PREVOST

WARRANTY BULLETIN

WB24-23

DATE :	July 2024	SECTION:	06 ELECTRICAL
EXPIRATION:	July 2026		
SUBJECT:	CB5 BREAKER INSPECTION

3. Locate CB5 breaker.

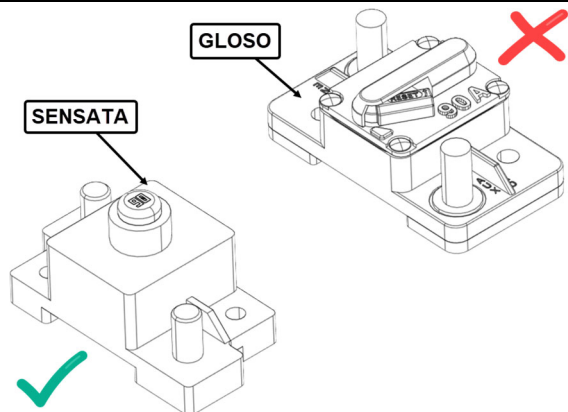
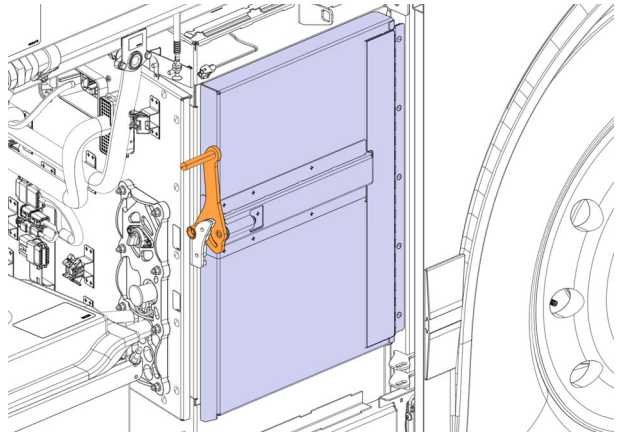
4. Verify if the breaker brand:

- If it is a **SENSATA** brand this ok, go to next step.
- If it is a **GLOSO** brand you need to replace it, go to breaker replacement section.

2. Locate CB5 breaker.

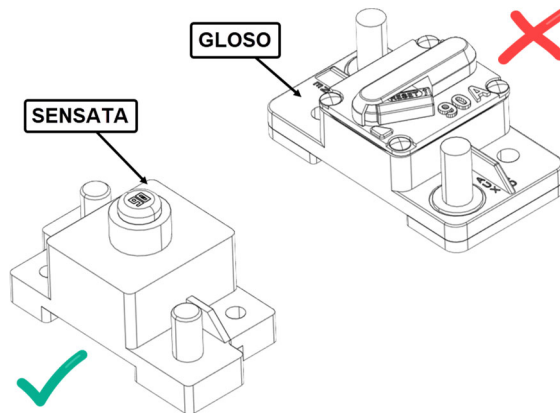
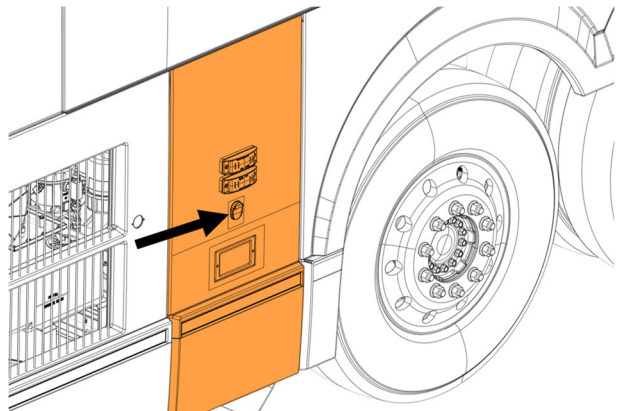
3. Verify if the breaker brand:

- If it is a **SENSATA** brand this ok, go to next step.
- If it is a **GLOSO** brand you need to replace it, go to breaker replacement section.

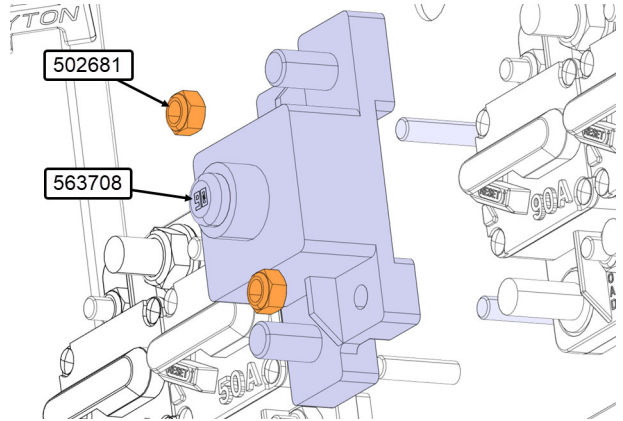
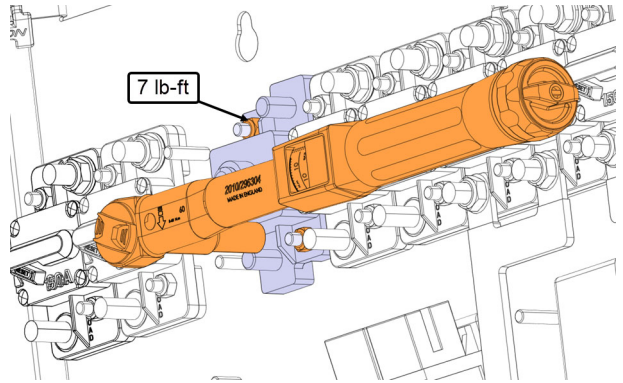
18. Install the new breaker CB5 563708 with new nuts 502681 (2x).

19. Tighten the nuts to **7 lb-ft** torque.

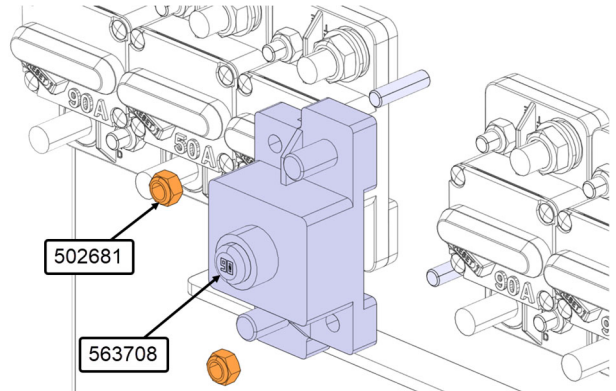
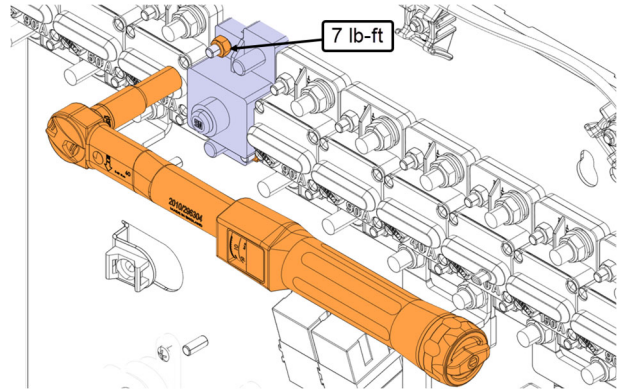
18. Install the new breaker CB5 563708 with new nuts 502681 (2x).

19. Tighten the nuts to **7 lb-ft** torque.
